PERMIT

P 535919

Septic Repair ON-SITE SEWAGE DISPOSAL SYSTEM HOWARD COUNTY HEALTH DEPARTMENT BUREAU OF ENVIRONMENTAL HEALTH

ADDRESS: 7069 MINK HOLLOW ROAD PHONE NUMBER: 202-262-7308

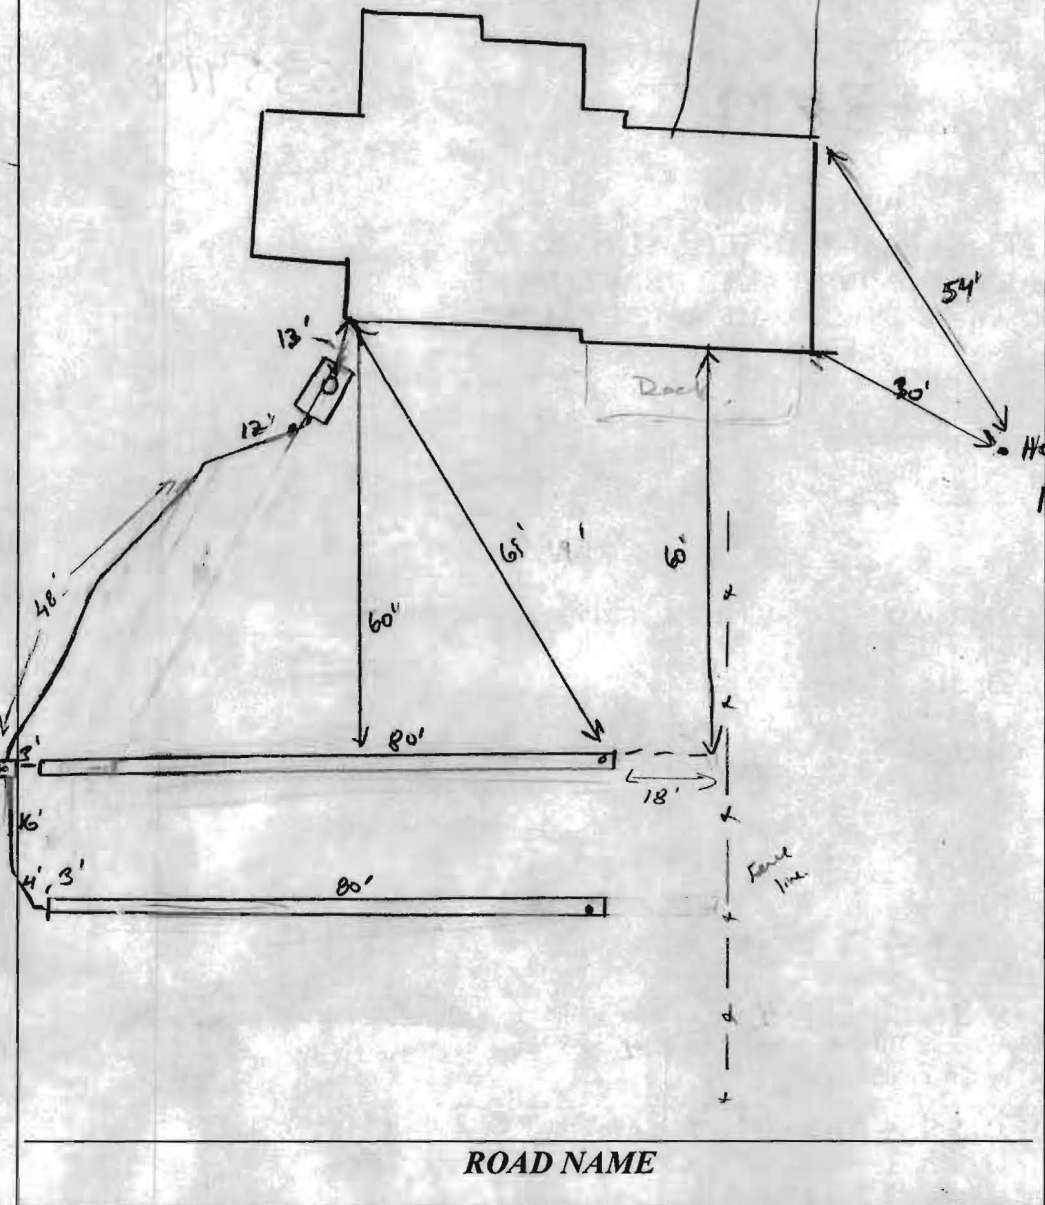
TRENCHES:	Trenches to be <u>3</u> feet wide. Inlet <u>4</u> feet below original grade. Bottom maximum depth <u>6</u> feet below grade. Effective area begins at <u>4</u> feet below original grade with _____ feet of stone below distribution pipe.
LOCATION:	CONTRACTOR REQUESTS TRENCH DESIGN FOR 6 BEDROOMS (4 EXIST). <u>2x 80' trenches</u>
PURPOSE:	REPAIR FAILING SYSTEM.

7/29/11 Layout w/ homeowner. OK to install spec's as shown on permit. After about an hour and a half of explanation on septic installation, Install 2x 80' trenches on center. as shot in field. Clean #2 Stone is to be used. (KW)

8/2/11 lower trench dig. Stone on site. Told owner ok to store and pipe tanks 8/3/11 lower trench complete. OK to Deck fill trench and continue (KW)

8/8/11 Bath trenches complete. Starting on plumbing from tank to trenches (KW)

8/9/11 Homeowner had messed up on pipe from tank to Dbox. Dbox set wrong. Need sch 40 pipe not SD226 (lightweight)

8/11/11 System finally complete. OK to cover all work.
